# ALBANY UNIFIED SCHOOL DISTRICT SEISMIC EVALUATION

Prepared for WLC Architects and Albany USD

KPW Project No. 13C133

April 24, 2013

Figure 1: Typical Wall-Roof Connections

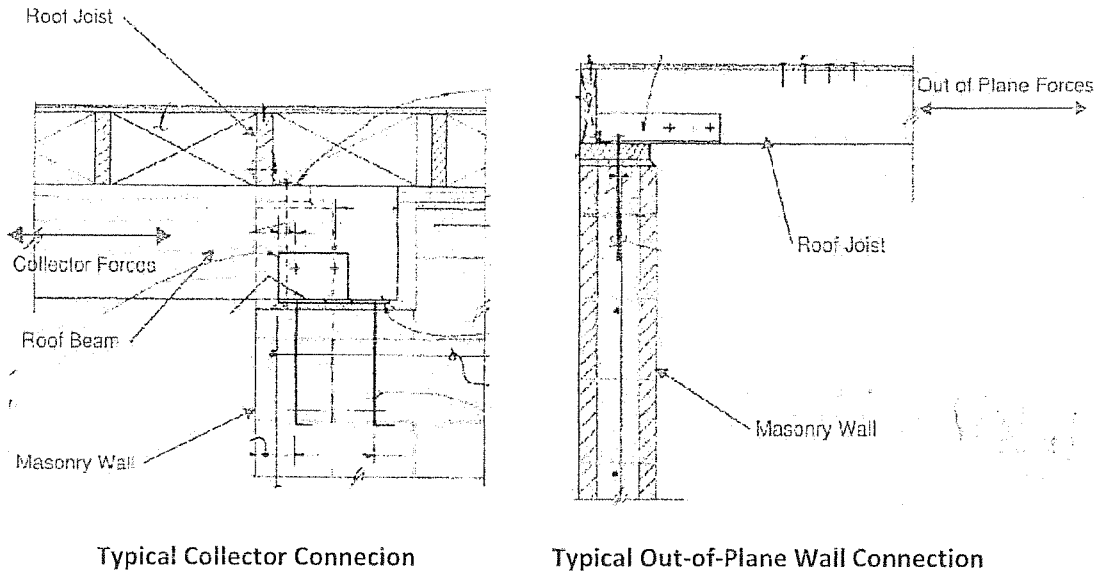
Our analysis found that in general the collector connections are significantly overstressed when compared to current code level forces. Refer to Figure 1 for a typical collector connection.

The out-of-plane wall connections at Ocean View generally consist of a steel angle bolted to the side of a roof joist and the top of the masonry wall as shown in figure 1. Our analysis of these connections found that they are significantly overstressed when subjected to the design forces of the current building code.

We would recommend that these deficient elements be strengthened as part of an overall seismic retrofit program. Retrofits of this nature are commonly performed and often can be implemented economically and with a minimal impact to the function or appearance of the buildings.
